ADA Curb Ramp New Construction Inspection Form (Parallel)

NW Timeric

23885.56

NW Belgium

PARALLEL RAMP (PL)

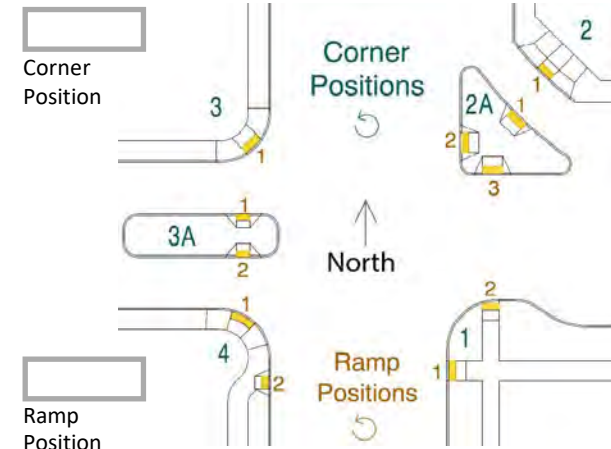
$\leq 1/4"$ ☐ $> 1/4"$ ☒

2.1 $\leq *$ ☐ $> *$ ☒

☐ 9.72 $\leq 8.3\%$ ☐ $> 8.3\%$ ☒

9.3 $\leq 2.0\%$ ☐ $> 2.0\%$ ☒

11.2 $\leq 2.0\%$ ☐ $> 2.0\%$ ☒

NTD RR1 TS Fail
